**Business Unit:** Electric **PCN/20/002/C+N-US**

**Product range:** Han Modular Date: 02/05/2020

**Title:** Han Quintax Module Page 1/2

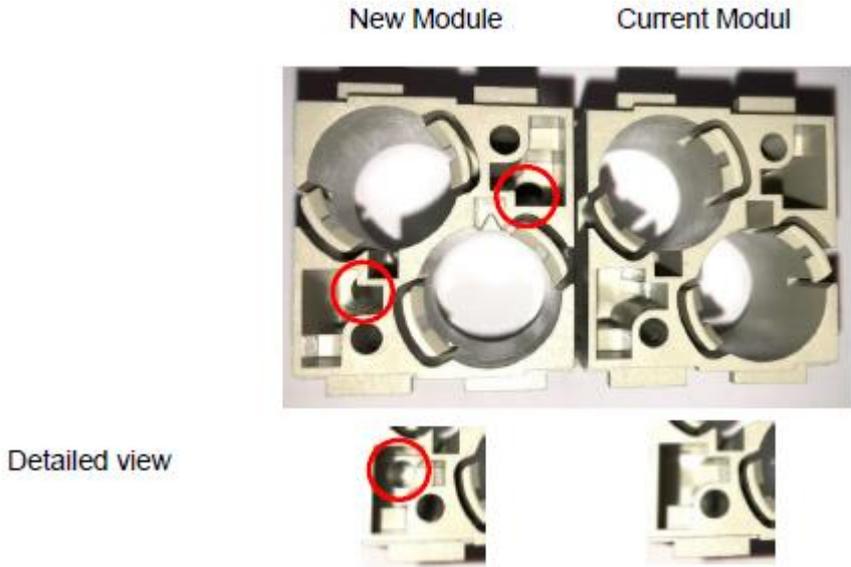
The Han Quintax Female modules and the Han HV Female modules (16A and 40A) now have a minor modification to improve manufacturability and improve lifetime of the product.
